**JOINT REGIONAL PLANNING PANEL  
(Sydney East Region)**

<b>JRPP No</b>	2013SYE046
<b>DA Number</b>	LDA2013/0165
<b>Local Government Area</b>	City of Ryde
<b>Proposed Development</b>	Construction of three residential flat buildings containing a total of 218 apartments and 305 car parking spaces
<b>Street Address</b>	600 Victoria Road, Ryde
<b>Applicant/Owner</b>	Frasers Putney Pty Ltd
<b>Number of Submissions</b>	1 submission received
<b>Recommendation</b>	Approval with Conditions
<b>Report by</b>	Sandra Bailey, Team Leader Major Development

**Assessment Report and Recommendation**

Figure 7. Section through Building 2A1 demonstrating the terrace area that is below natural ground level.

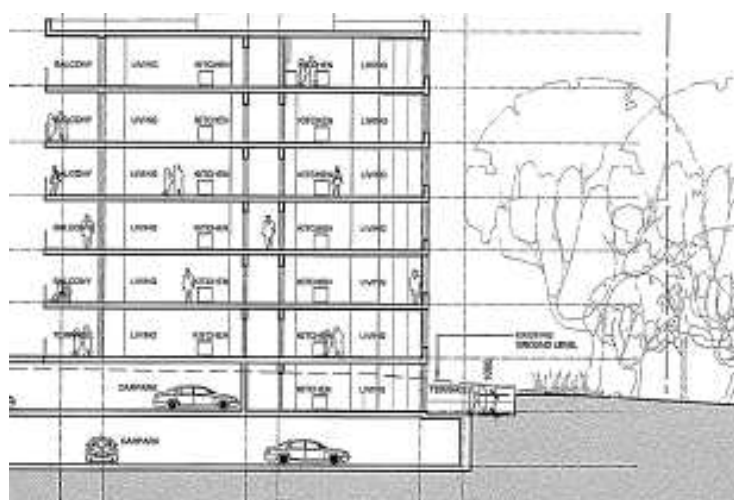
*The panel notes that in section AA Building 2A1 shows what appears to be ground level units and terrace below ground level. More detail is needed to understand how the edge of the terrace is defined (fences/walls/planting) to ensure this units along this edge receive good amenity.*

**Comment:** The Panel were concerned that a number of the units and terraces were located below the finished ground level. This is occurring due to the slope of the site. In terms of Building 2A1, the terrace area for one of the apartments along the north western elevation will be below natural ground level by 1 metre at the worst point. This is demonstrated on the following Figure.

Given that the terrace is on the NW elevation and that adequate daylight will be provided to this terrace, the amenity of the apartment will not be adversely affected.

Figure 11. Building separation distances.

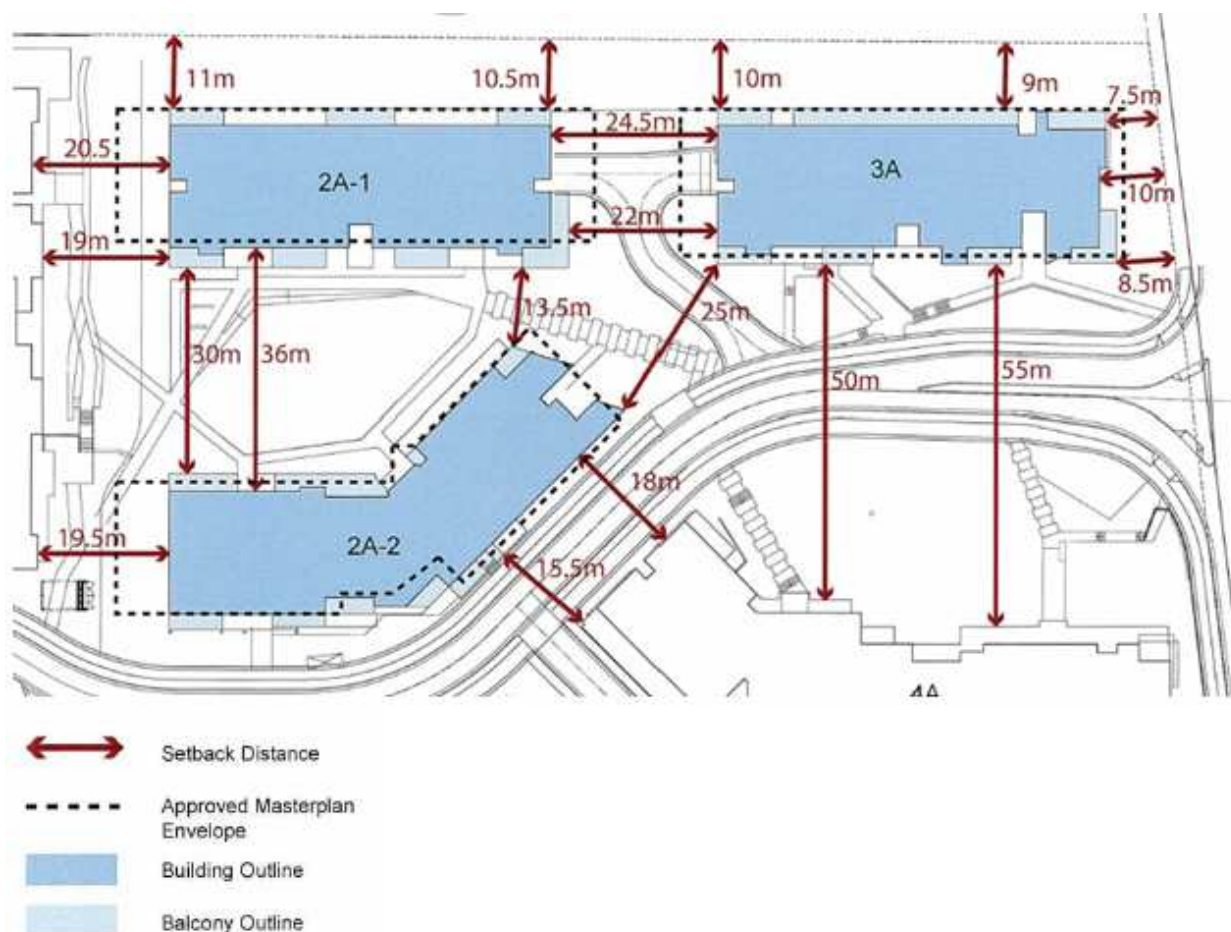
The development generally complies with the required building separation distances of 18m however there are 2 areas of non compliances which are discussed below.

Figure 12. Building Separation between buildings 2A1 and 2A2.

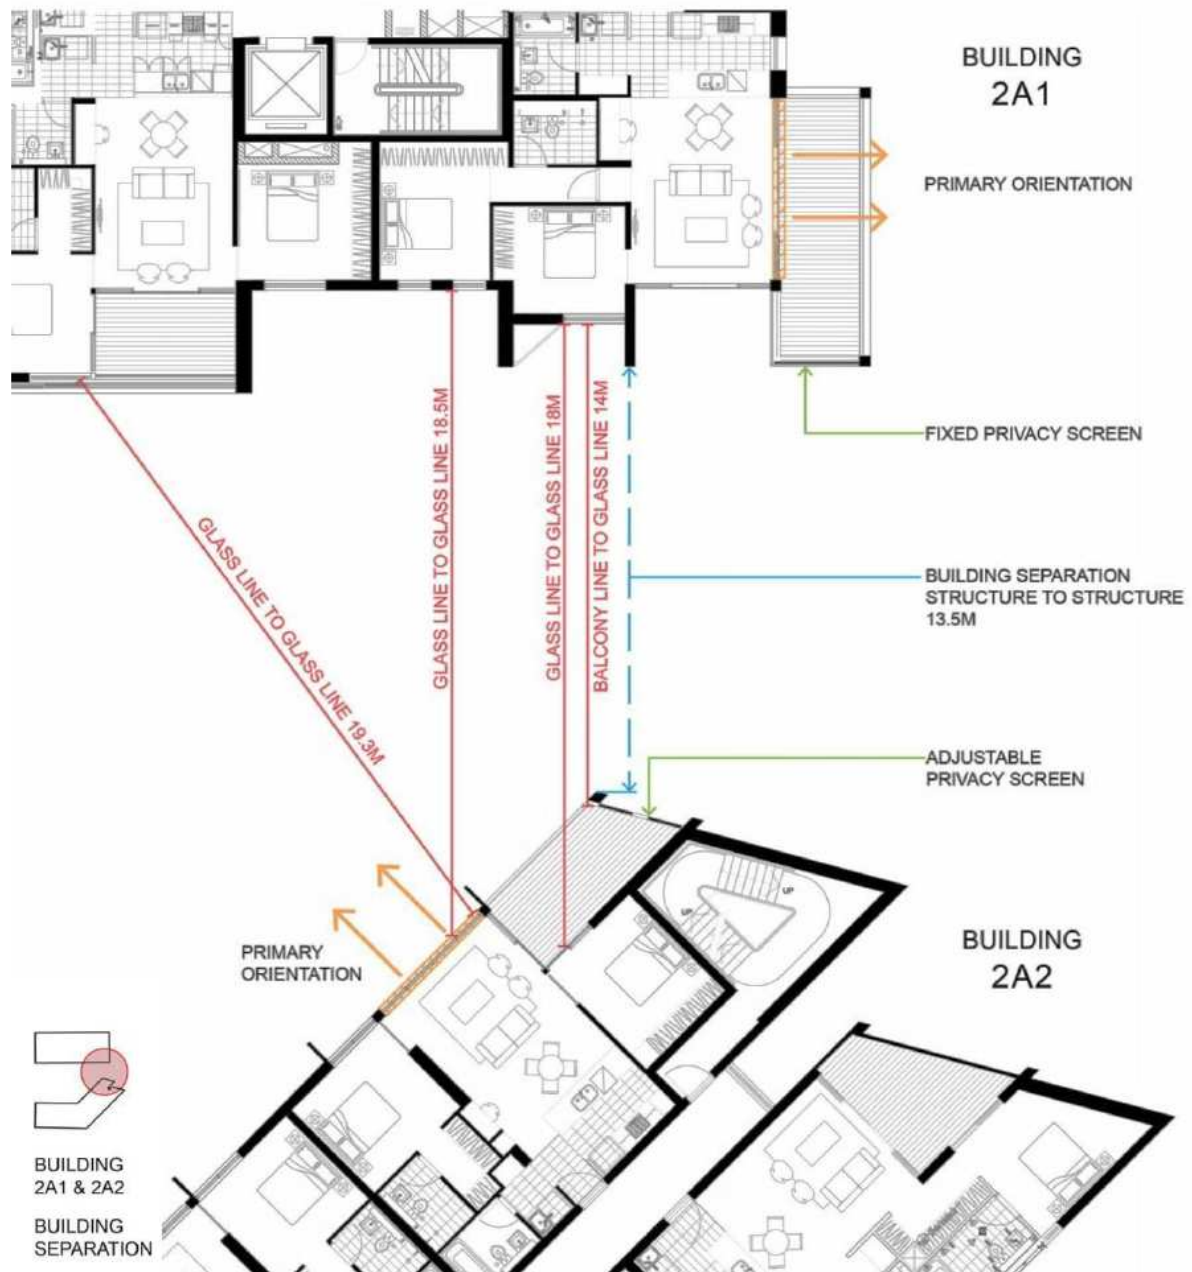
The separation distance between the north western corner of building 2A2 and Building 2A1 is 13.5m. This is demonstrated on the following more detailed figure. The applicant has advised that correct figure is 14m rather than 13.5m.

This issue occurs for the top two levels of the building only. The applicant has argued that the variation is acceptable as the orientation of each apartment is directed away from neighbouring apartments and that privacy screening is provided to the four apartments. The privacy screen is only provided at the end of the balcony

in Building 2A2. The main orientation of this balcony is towards Building 2A1. To address the issue, it is recommended that additional adjustable privacy screening be added to the main façade of the balcony on apartment 36 (level 5) and 43 (level 6). This has been included as a condition on the consent. (See condition number 1a). Subject to this arrangement, visual privacy will be acceptable.

Figure 14. Extract of the Building Heights and Setbacks Plan approved in the Concept Application (MP05\_0001 Mod 1) demonstrating that the maximum permitted building height is 25 metres for the RFB and 9.5 metres for the row houses

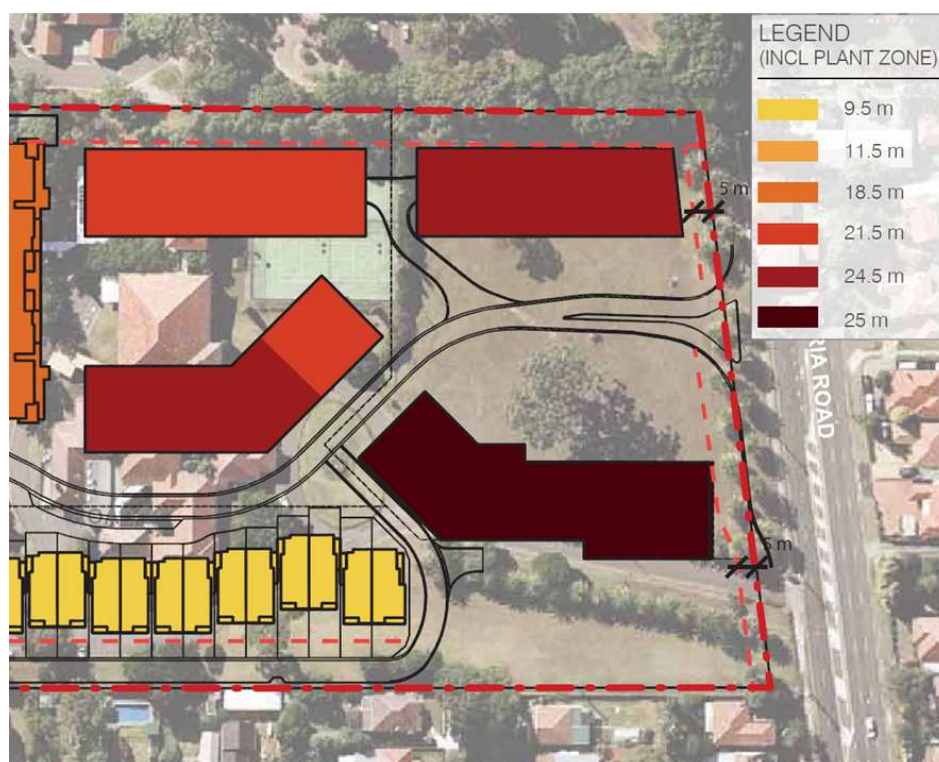
All three of the buildings exceed the height control as contained in RLEP 2010. However the height of the buildings has already been approved as part of the Concept Plan Approval MP05\_0001Mod 1. This is demonstrated on the following Figure.

In these circumstances consent can be granted without complying with the requirements of the RLEP 2010.
